CCK-2568-22

ADDENDUM # 4

CONSTRUCT/ IMPROVE GREEK HOUSING (DELTA GAMMA) Bid Package #2 – All Work Categories

UNIVERSITY OF KENTUCKY
 2555.0 Construct/Improve Greek Housing
 (Delta Gamma House)

DWG. NO.
AD102

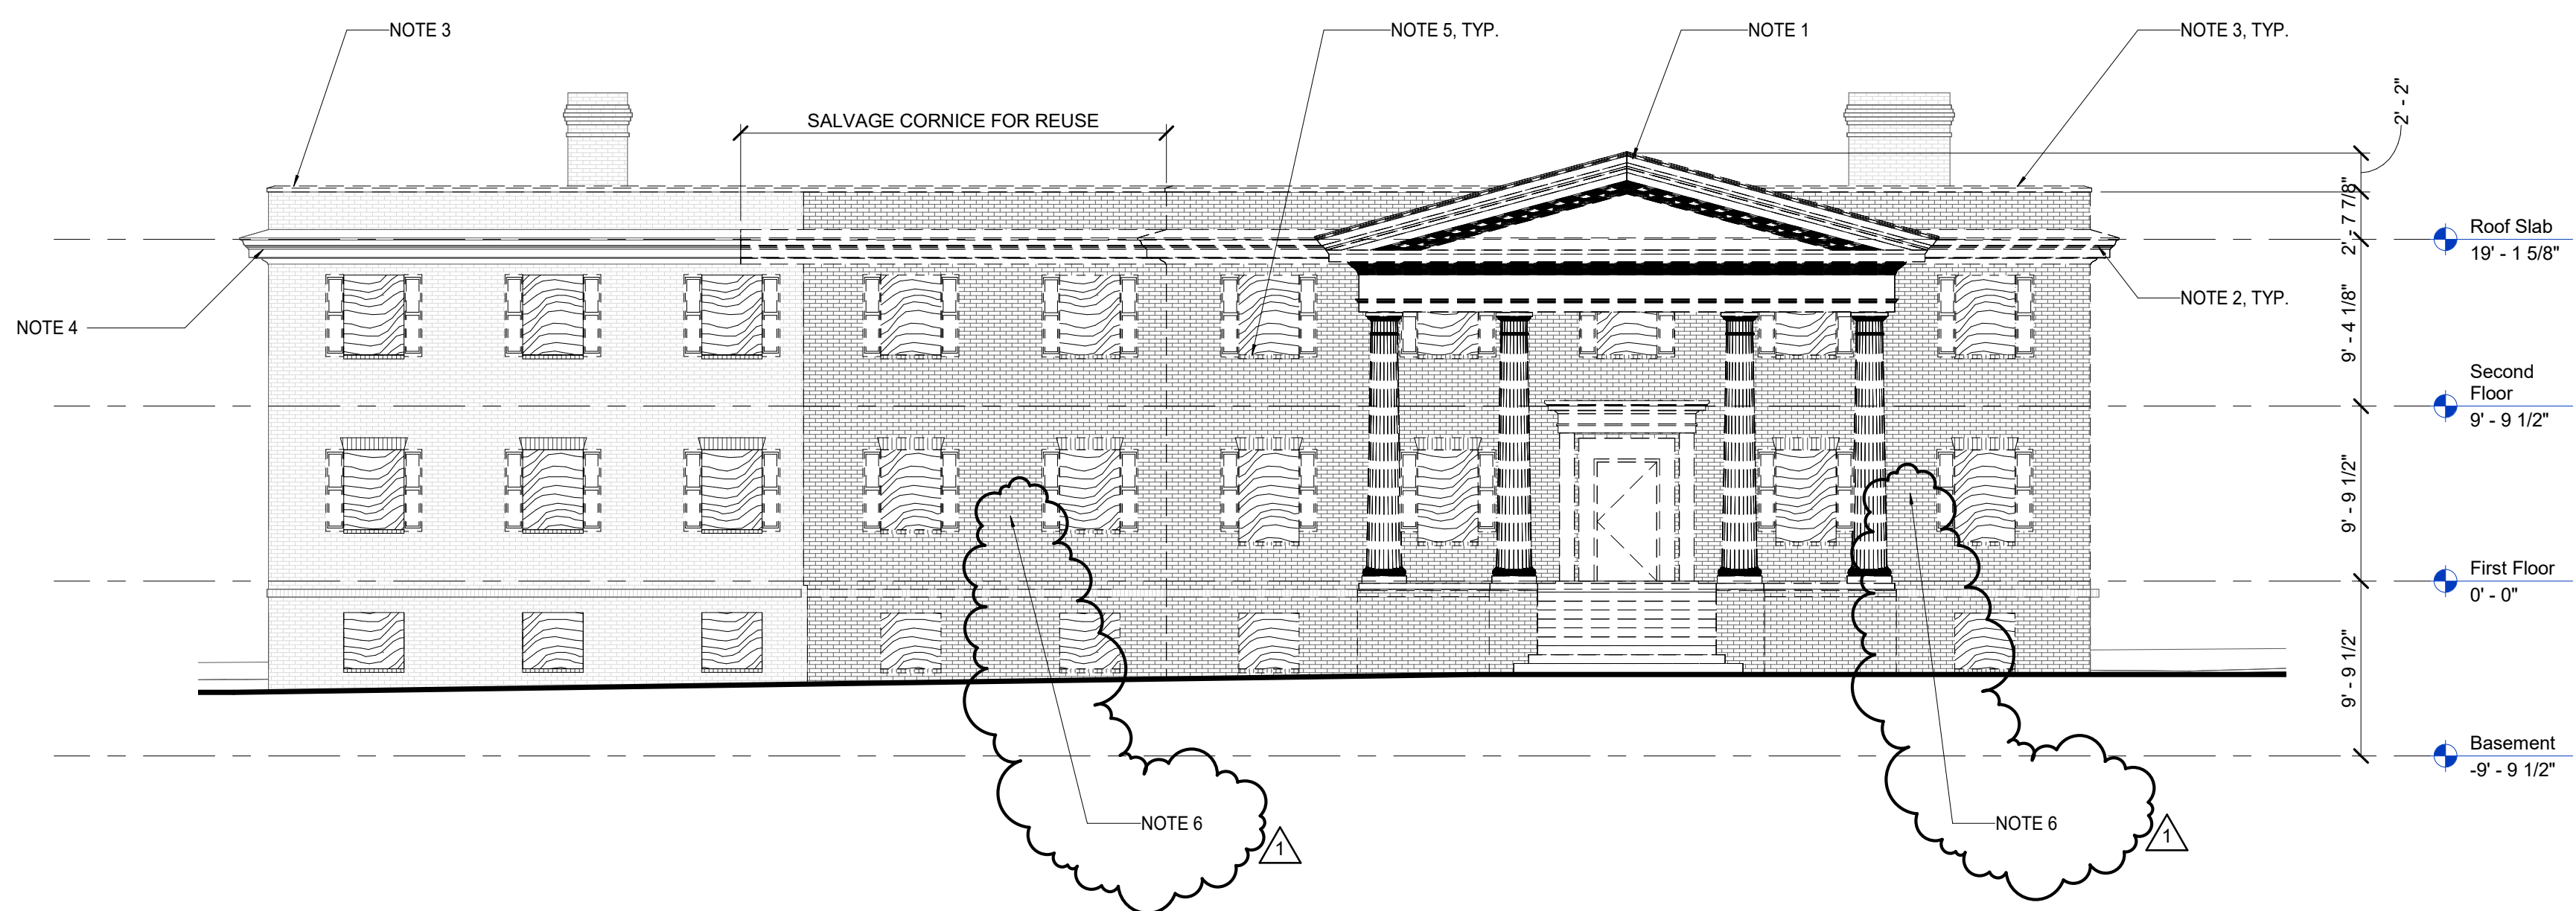
AD102	<p>DEMOLITION PLAN – LEVEL 02</p> <ul style="list-style-type: none"> • Added Sheet Specific Note 10: Wall being removed under separate contract. Wall removal show for reference only. All required shoring and related items still to be included in this scope of work. • Tagged note 10 on both stair walls, plan east and Plan South wall. 	9/7/21
AD201	<p>DEMOLITION ELEVATIONS</p> <ul style="list-style-type: none"> • Added Sheet Specific Note 6: Wall being removed under separate contract. Wall removal show for reference only. All required shoring and related items still to be included in this scope of work. • Tagged note 6 on F1: North Demolition Elevation, on both existing walls to be demolished. 	9/7/21
AD202	<p>DEMOLITION ELEVATIONS</p> <ul style="list-style-type: none"> • Added Sheet Specific Note 10: Wall being removed under 	9/7/21

separate contract. Wall removal show for reference only. All required shoring and related items still to be included in this scope of work.

A1 FLOOR PLAN - BASEMENT

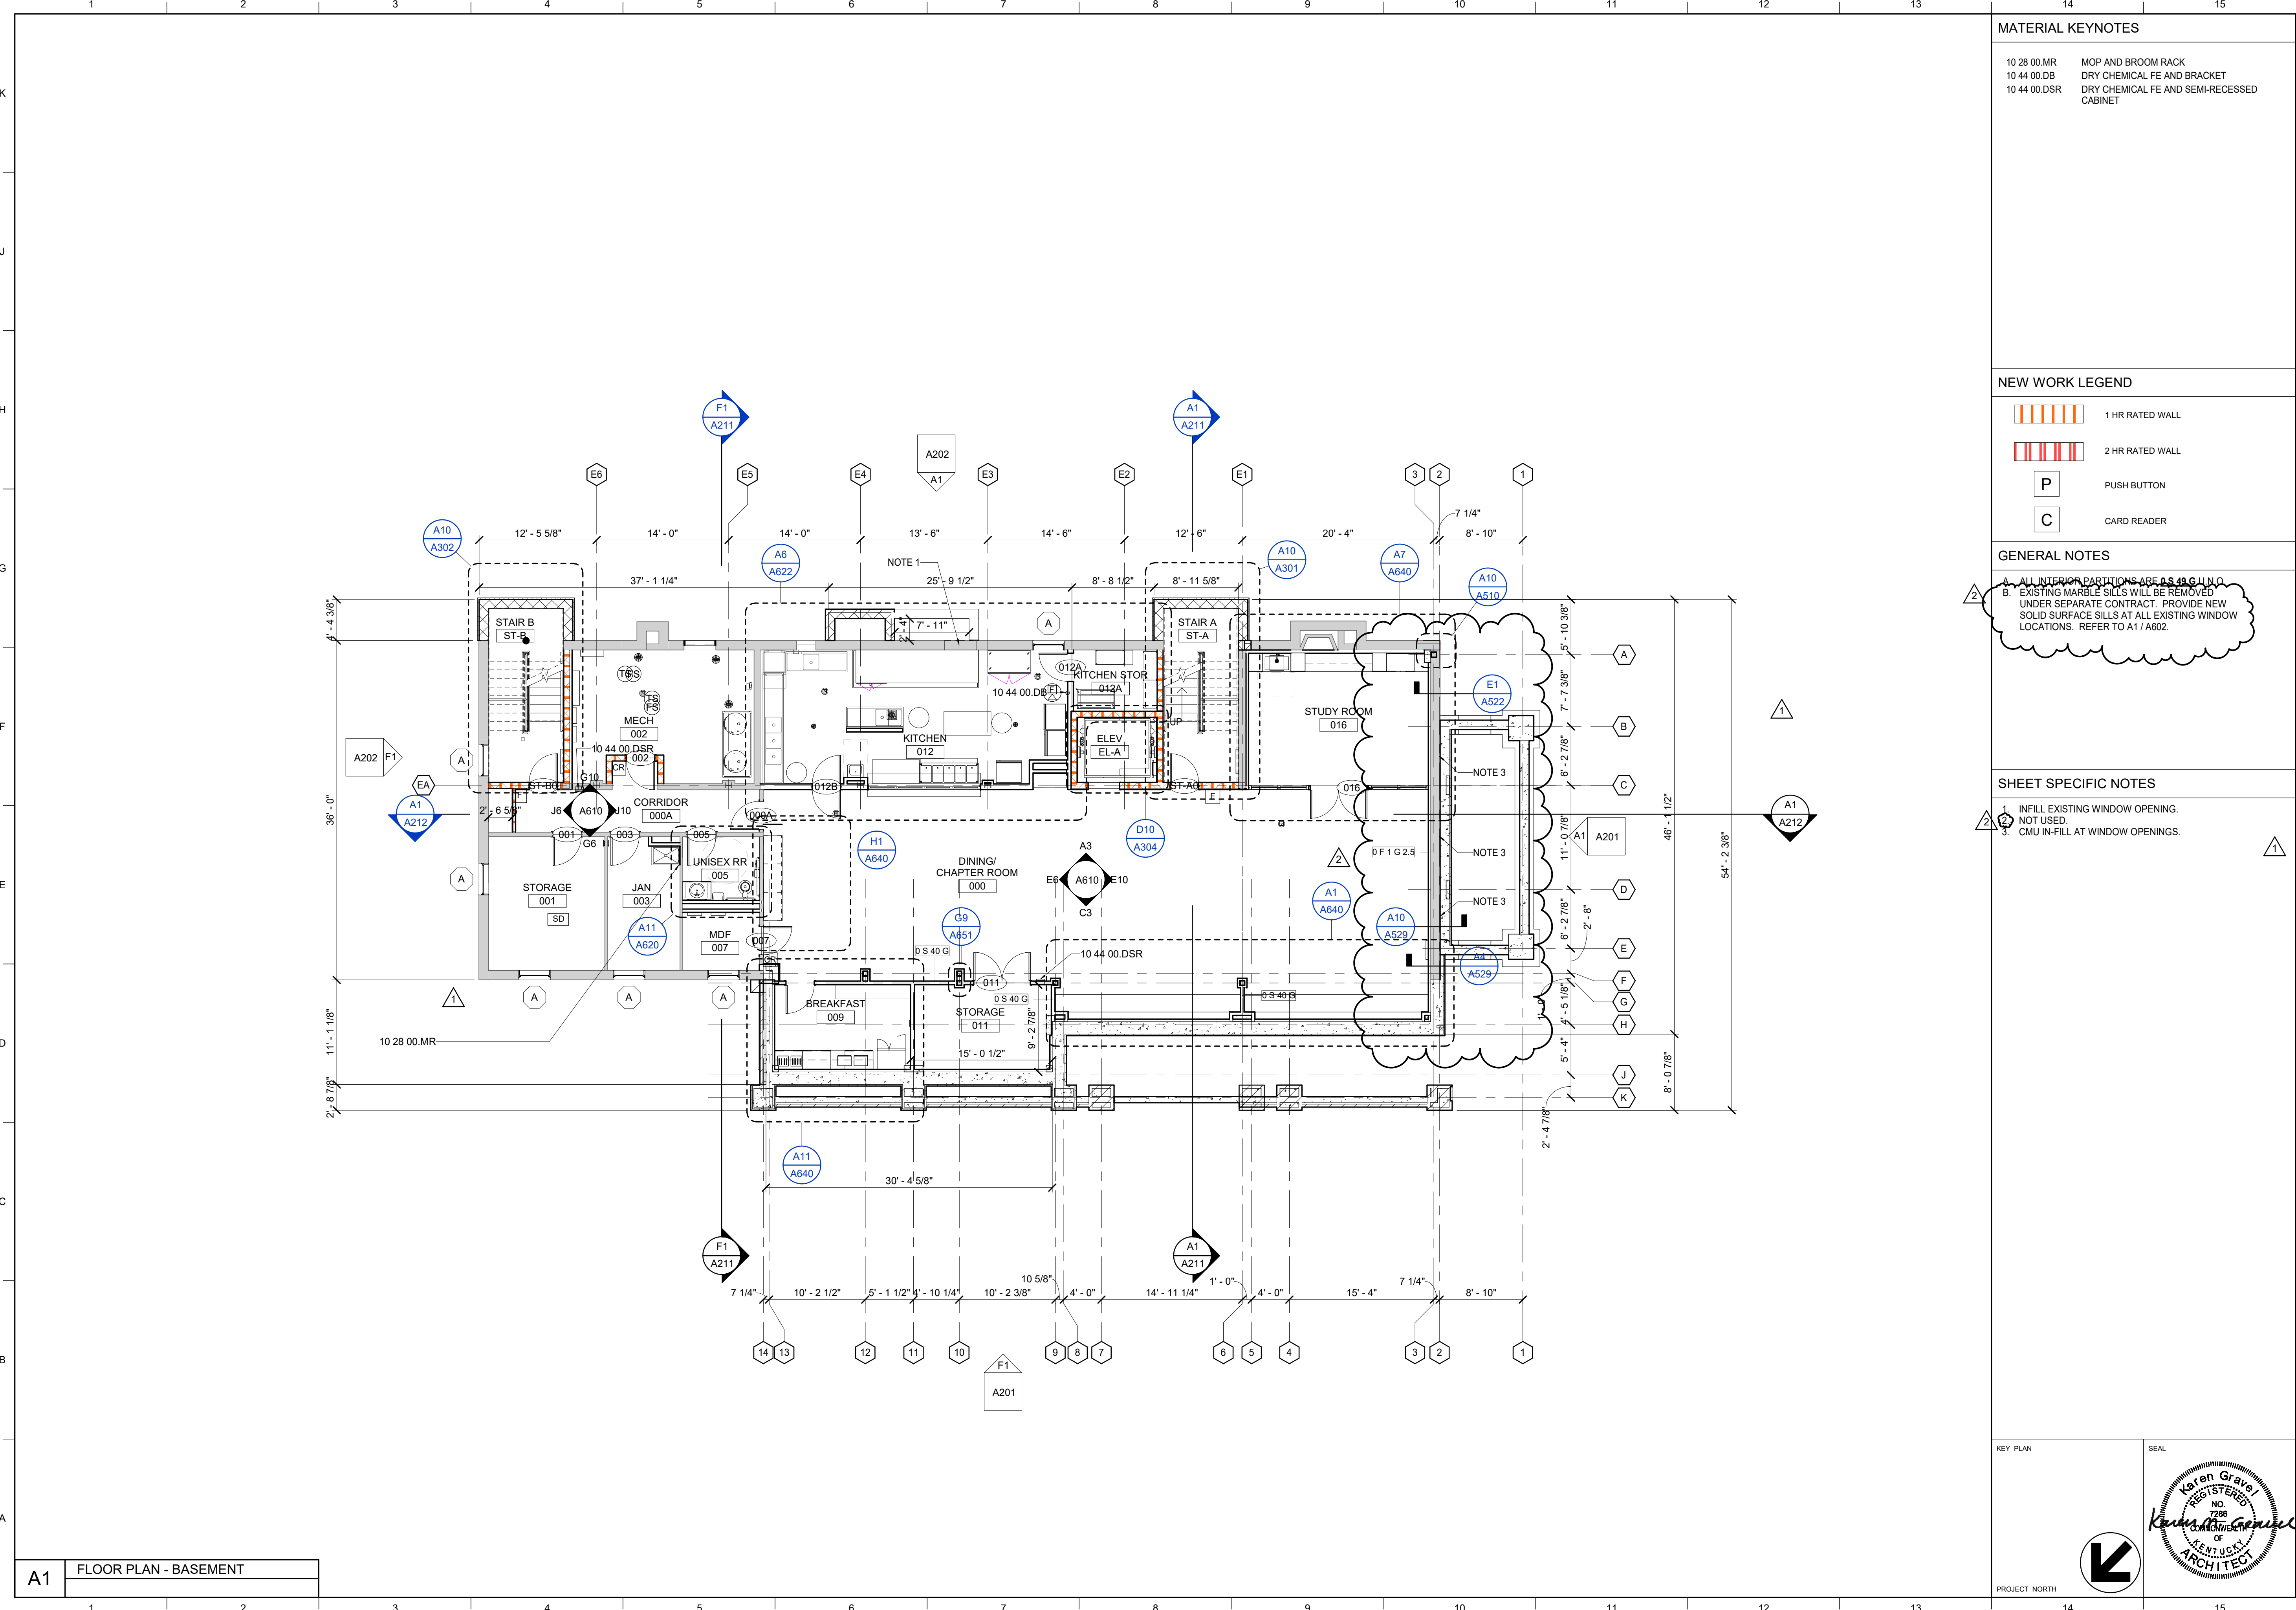
A100	FLOOR PLAN - BASEMENT	9/7/21
	<ul style="list-style-type: none"> • Removed Callout for Column Wrap since columns are no longer present in base bid. • Added wall section through existing / new construction wall at pier. • Added wall section through existing / new construction wall. • Added a General Note to provide new solid surface window sills at existing window openings. 	
A101	FLOOR PLAN – LEVEL 01	9/7/21
	<ul style="list-style-type: none"> • Added a General Note to provide new solid surface window sills at existing window openings. • New detail callouts added. 	
A102	FLOOR PLAN – LEVEL 02	9/7/21
	<ul style="list-style-type: none"> • Added a General Note to provide new solid surface window sills at existing window openings. 	
A226	ENLARGED ELEVATIONS & WALL SECTIONS	9/7/21
	<ul style="list-style-type: none"> • Adjusted basement foundations to represent the base bid without Basement expansion.

E1 WATERPROOFING DETAIL
0 6 12 IN

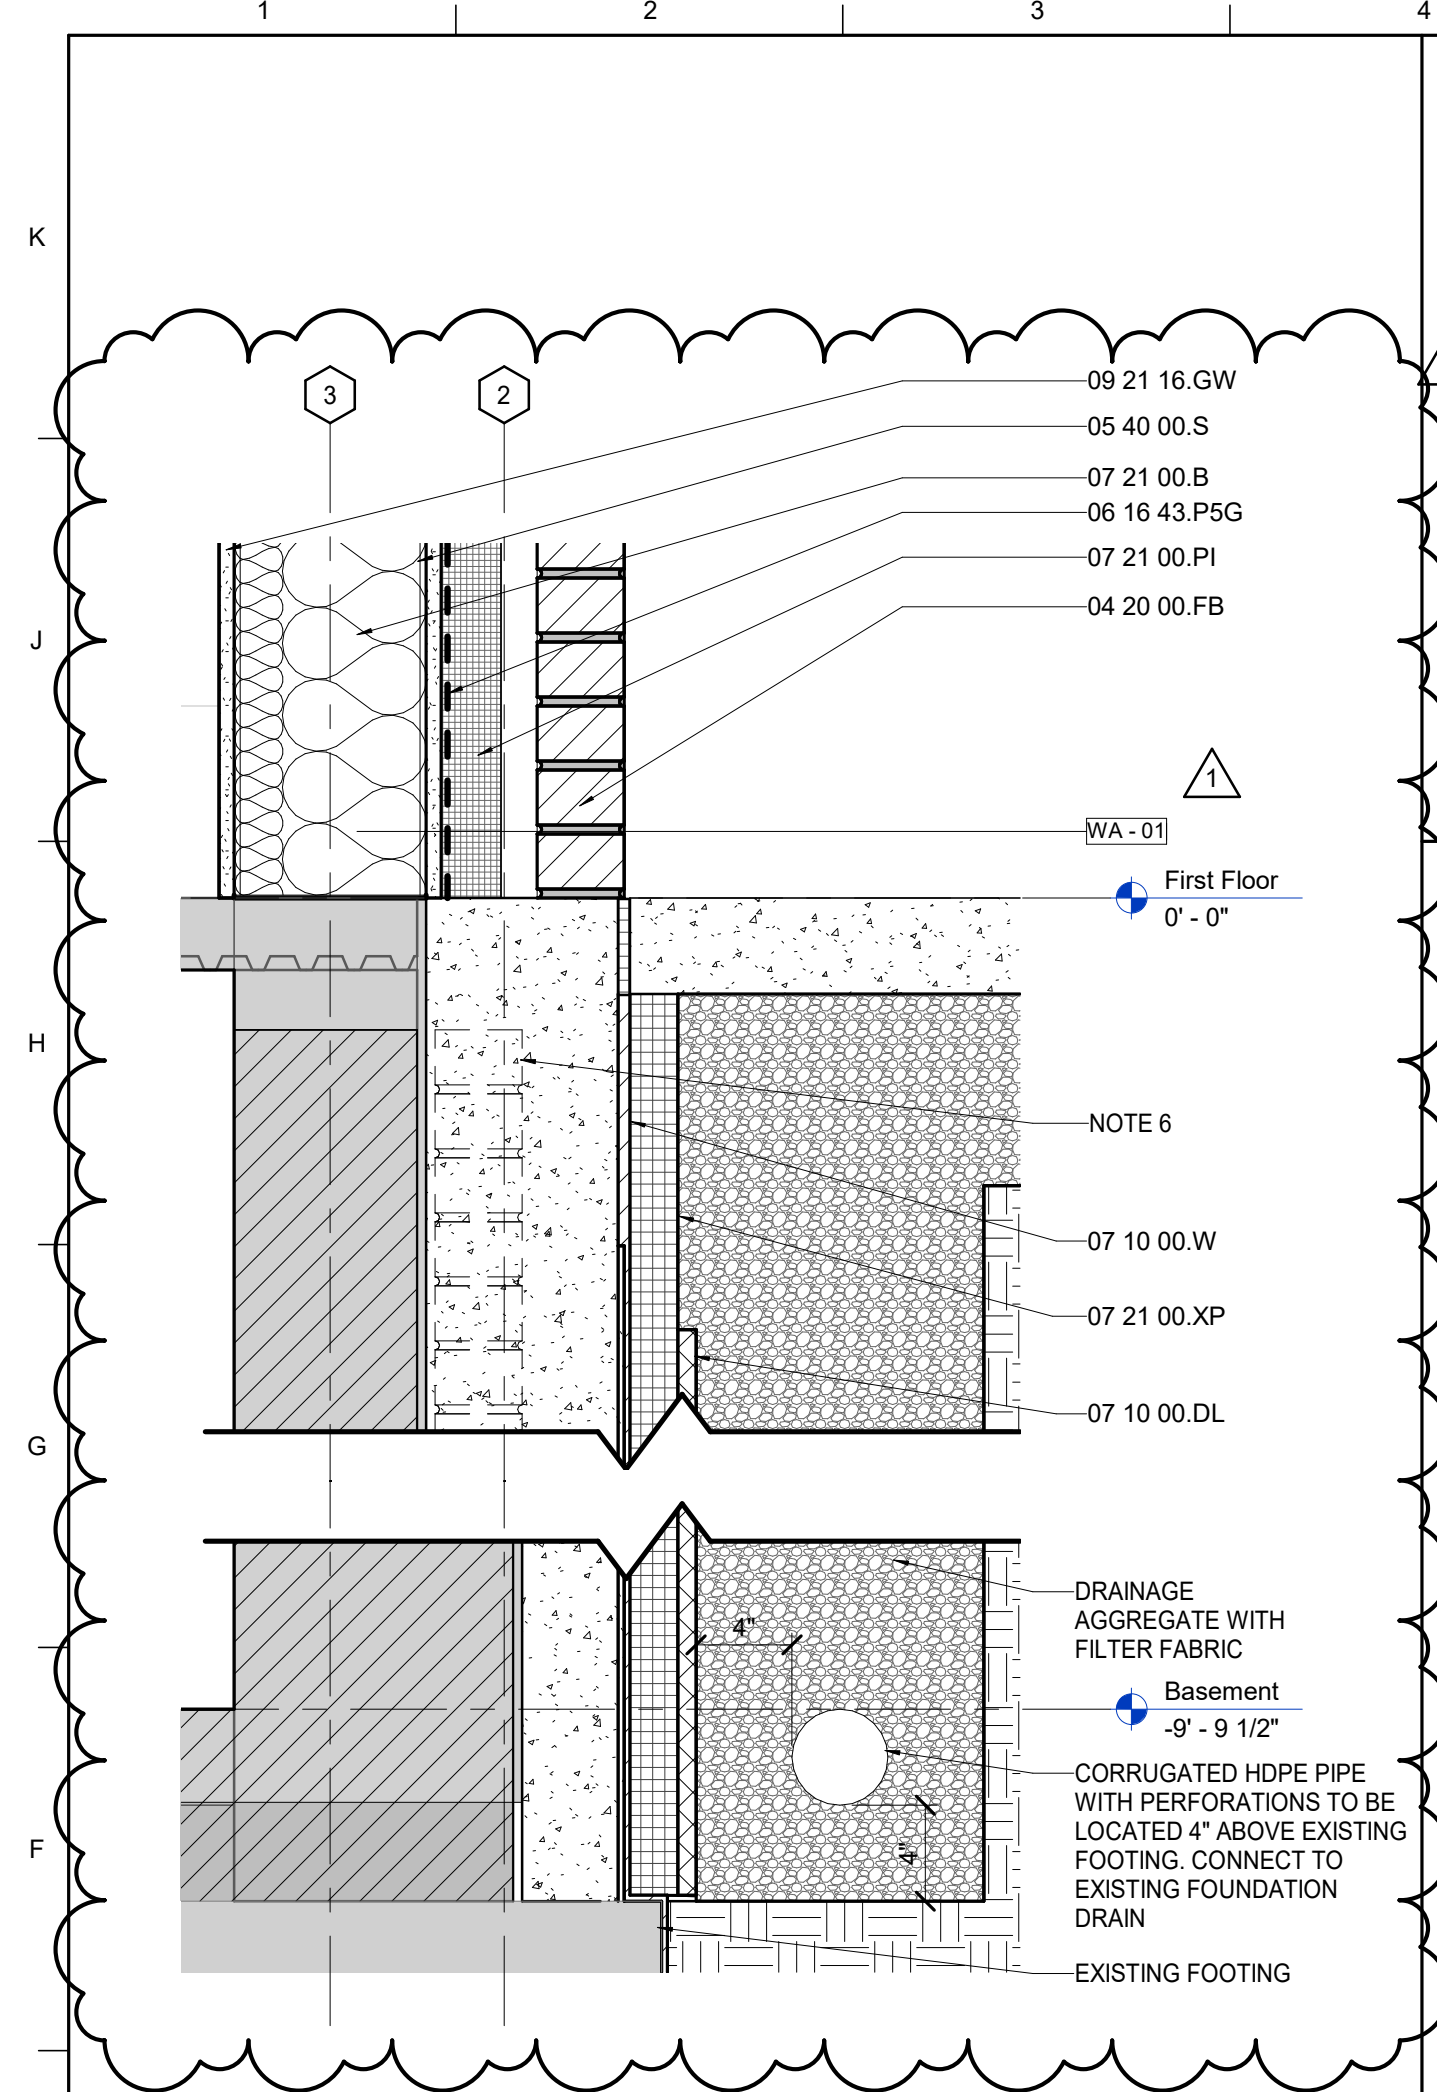
A522	EXTERIOR DETAILS - BRICK	9/7/21
	<ul style="list-style-type: none"> • With more Structural coordination, detail E1 – Waterproofing Detail has further been adjusted since Addendum 3 • Added Sheet Specific Note 6: Brick face being removed under separate contract. Brick removal shown for reference only. 	
A529	EXTERIOR DETAILS - BASEMENT	9/7/21
	<ul style="list-style-type: none"> • Added new sheet • Added wall section through existing / new construction wall at window infill. • Added brick transition detail at existing basement wall with new structural bracing wall to First Floor New construction. 	
A602	WINDOW SCHEDULE	9/7/21
	<ul style="list-style-type: none"> • Adjusted Note 1 to say New solid surface sill. Verify dimensions in field. • Adjusted the window detail A1 to show 1" Sill and 1" Overhang to match existing conditions with new sill. 	
A700	FINISH LEGEND	9/7/21
	<ul style="list-style-type: none"> • Revised ceiling finishes on Basement Level to match RCPs.
